June 16, 2021

Thank you for the opportunity to review the concept plan, for the Takoma Junction development – SHA Tracking #19APMO008xx in Montgomery County, Maryland. The Maryland Department of Transportation State Highway Administration (MDOTSHA) review is complete, and we are pleased to respond.

MD 195 (Carroll Avenue) at Site Driveway

DATE: 6/3/2021	SHEET NO: 1 of 4
PREPARED BY: SH	REV BY/DATE:
CHECKED BY: AP	REV CHK BY/DATE:
SUBJECT: Intersection Sight Distance Observations Right Turn Maneuver (Eastbound)

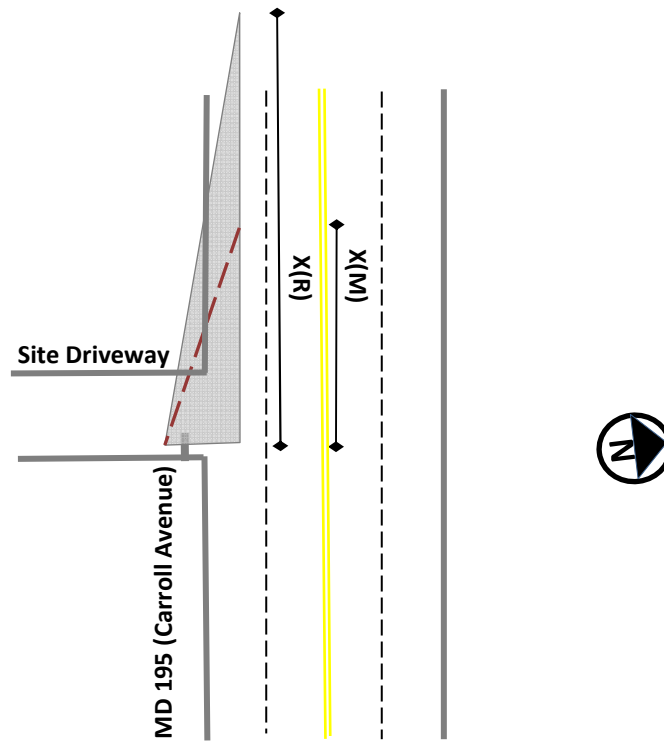
Measured intersection sight distance is less than recommended intersection sight distance.
Posted Speed Limit: 25 mph
Prevailing/Design Speed: 35 mph
AASHTO Greenbook, Sight Distance - Case B2: Right Turn from Stop

DATE: 6/3/2021	SHEET NO: 2 of 4
PREPARED BY: SH	REV BY/DATE:
CHECKED BY: AP	REV CHK BY/DATE:
SUBJECT: Stopping Sight Distance Observations Right Turn Maneuver (Eastbound)

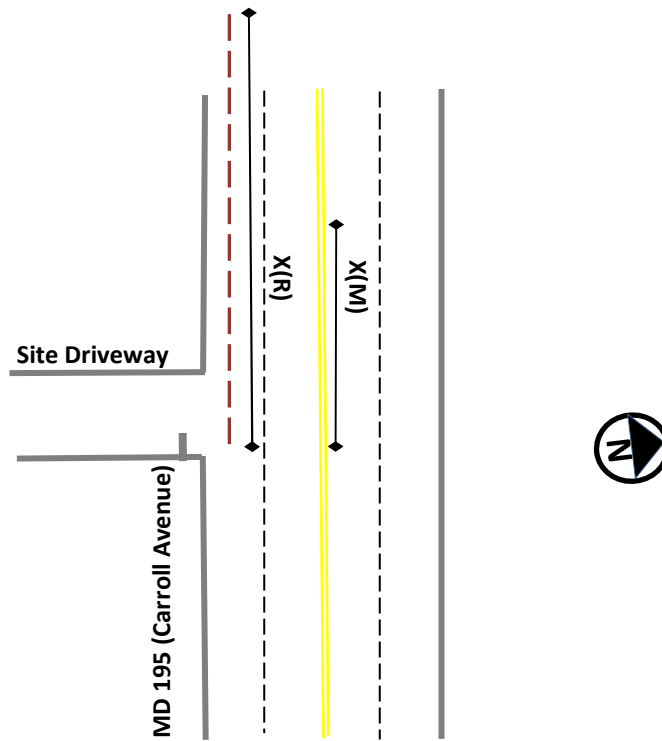
Measured stopping sight distance is less than recommended stopping sight distance.
Posted Speed Limit: 25 mph
Prevailing/Design Speed: 35 mph
AASHTO Greenbook, Sight Distance - Case B2: Right Turn from Stop

Picture 1 – Intersection Sight Triangle from Proposed Driveway Blocked by Vegetation on Adjacent Lot

Picture 2 – Intersection Sight Triangle Opposite View Blocked by Vegetation on Adjacent Lot

Picture 3 – Intersection Sight Triangle from Advance Position

Picture 4 – Stopping Sight Distance Limited by Utilities and Vegetation

Figure 1. Sight Line Obstructions

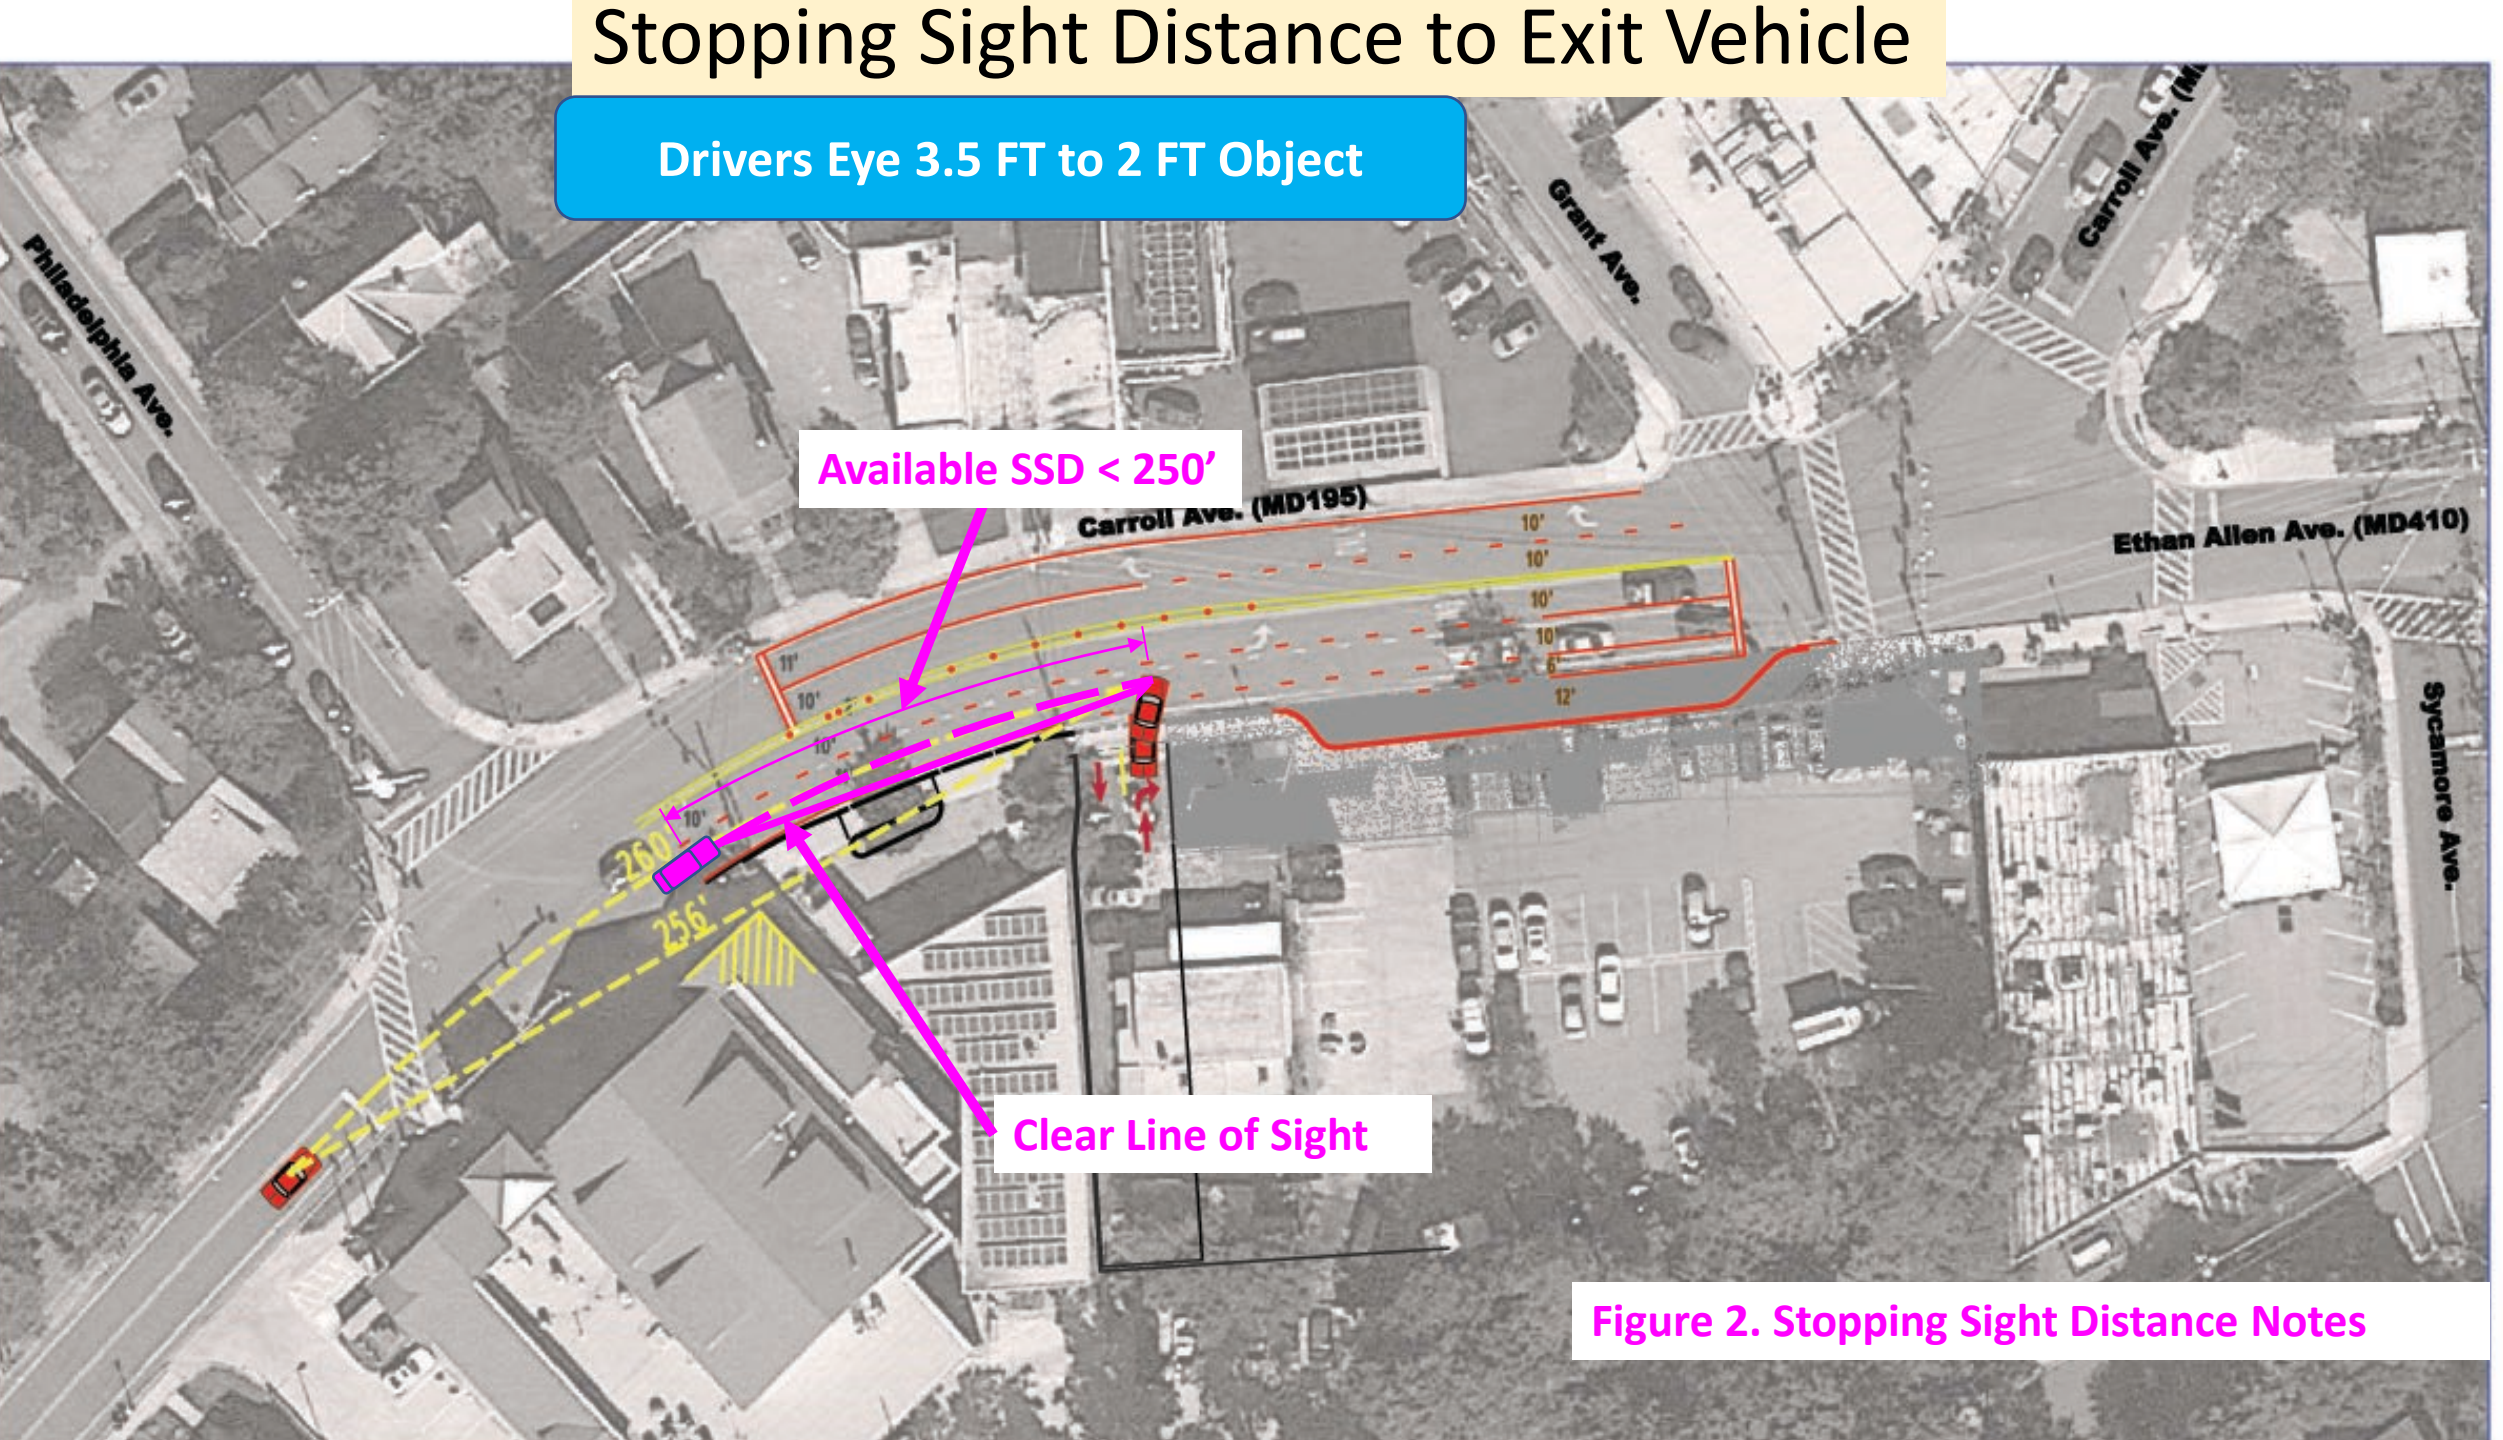
Attached to this letter are markups of previously submitted material which shows obstructions along the line of sight which prevent the reported stopping sight distance from being obtained. This includes trees and utilities. With the issues noted, we are unable to evaluate the proposed sight distance conditions and make a determination on adequacy and what measures may be available or are necessary to improve the available sight distances for the proposed access with the information provided.

EXISTING
BUILDING BLOCKS
SIGHT DISTANCE

Driveway and vehicle not visible from location reported

**Line of Sight obstructed
by utilities and trees.
See photograph.**

EXISTING
FIRE HOUSE BLOCKS
SIGHT DISTANCE

Figure 2. Stopping Sight Distance Notes

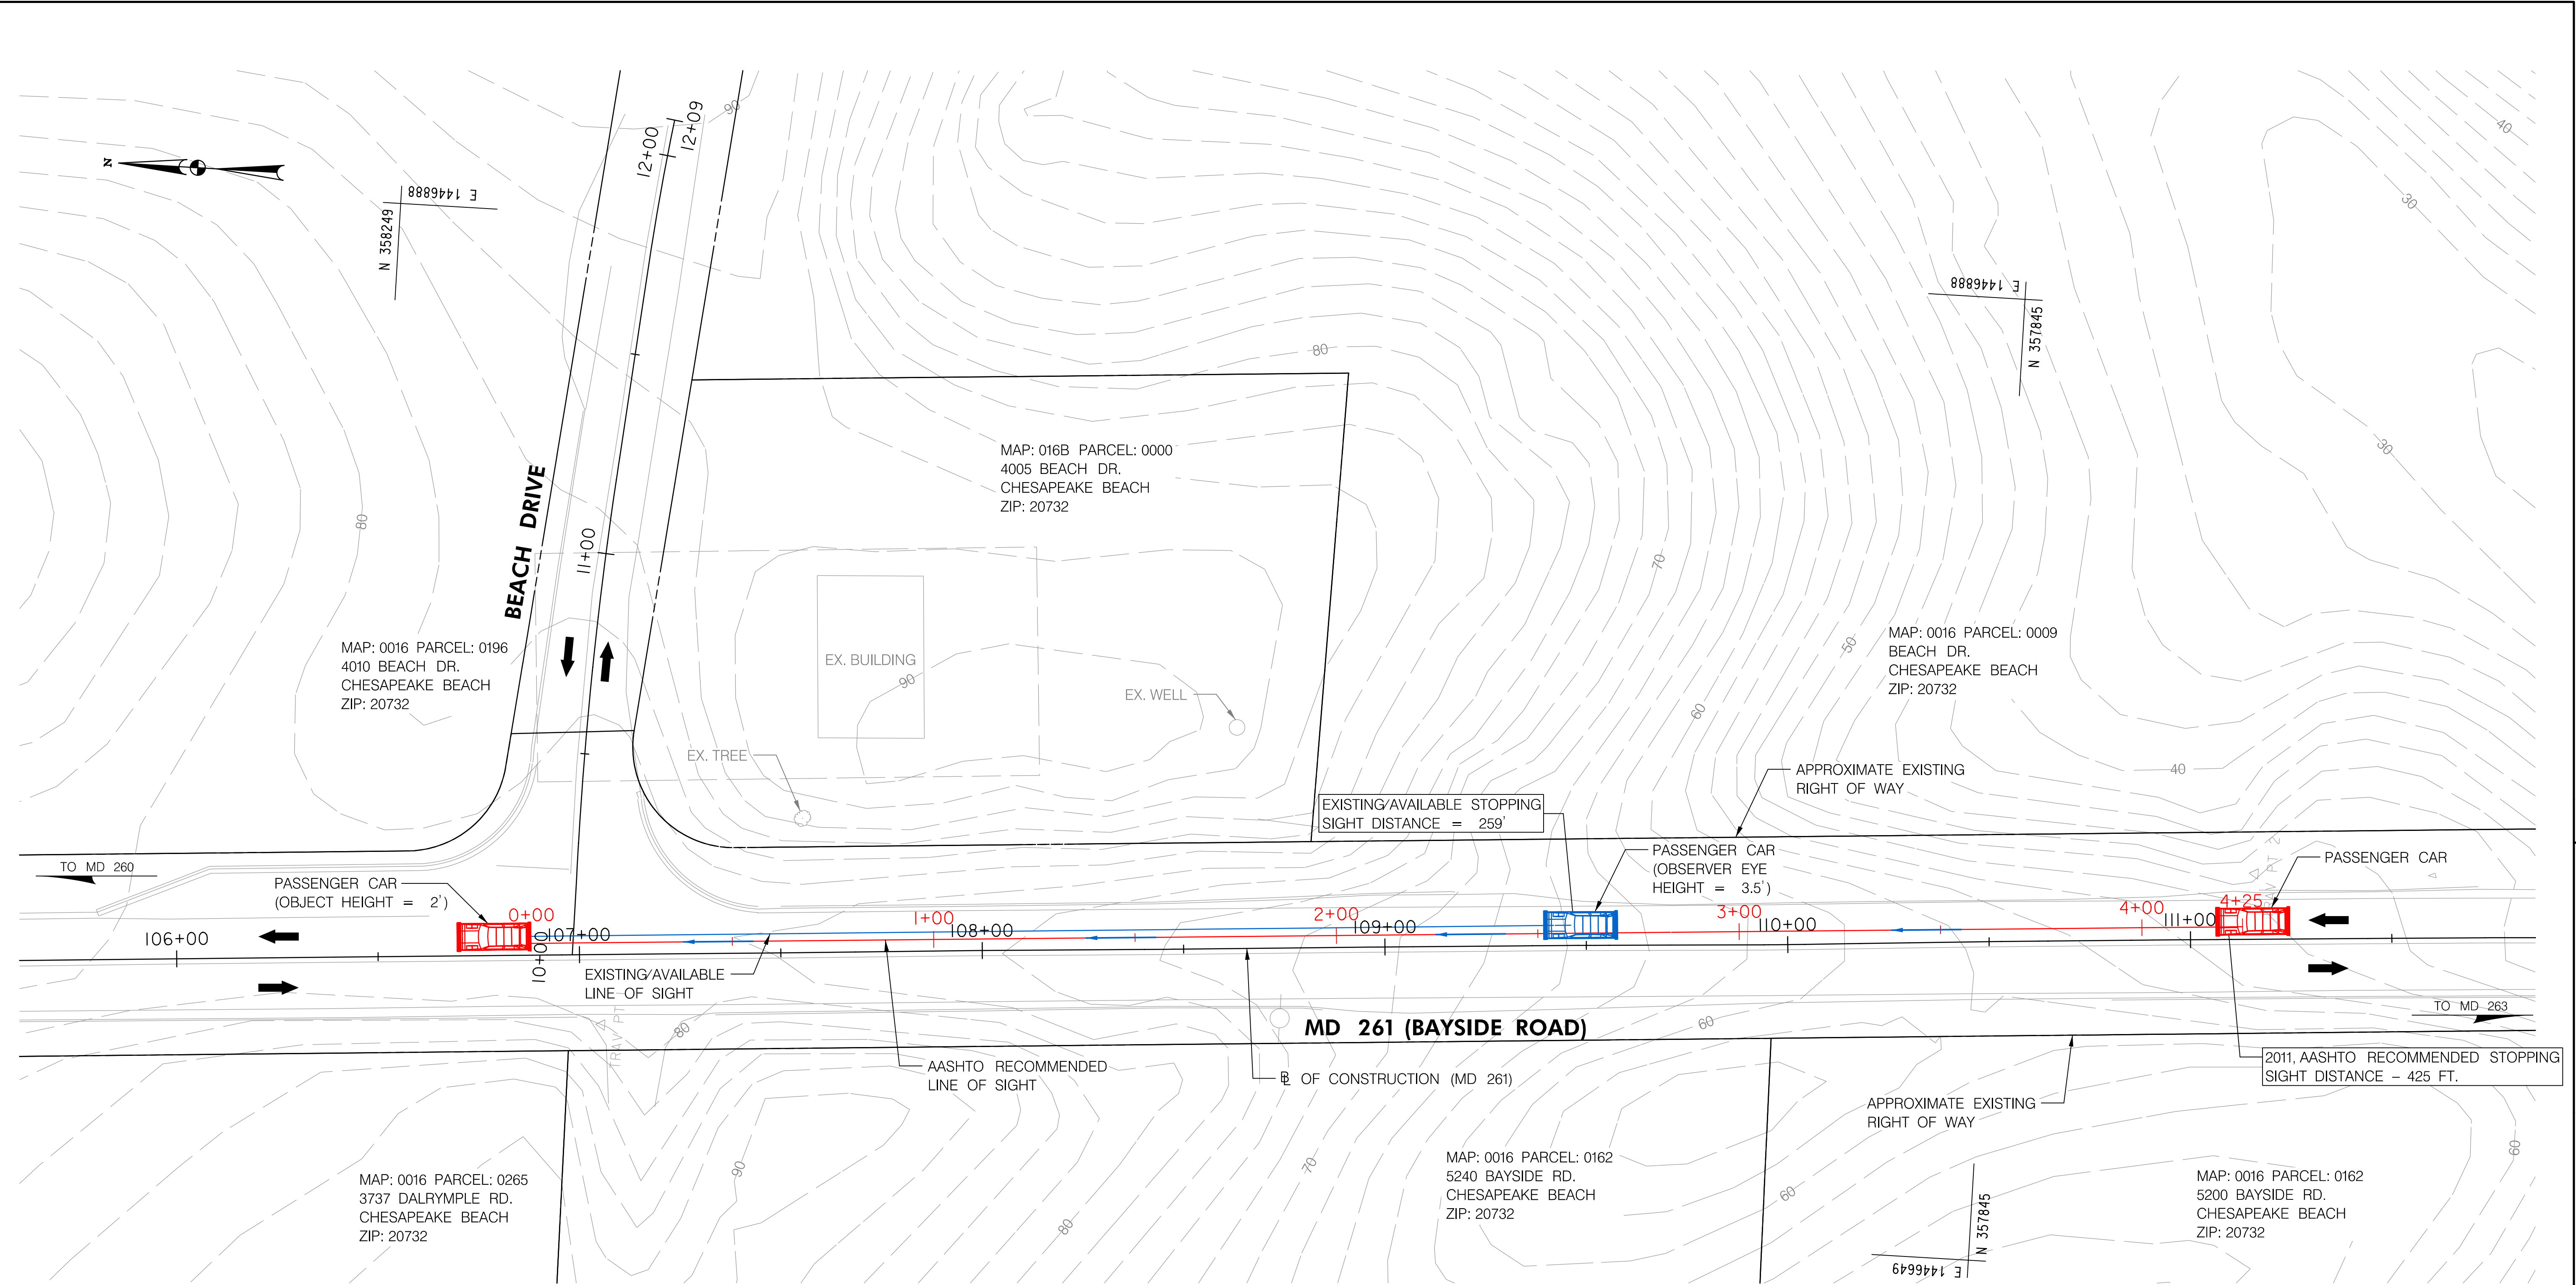
Stopping Sight Distance to Exit Vehicle

Drivers Eye 3.5 FT to 2 FT Object

Available SSD < 250'

Clear Line of Sight
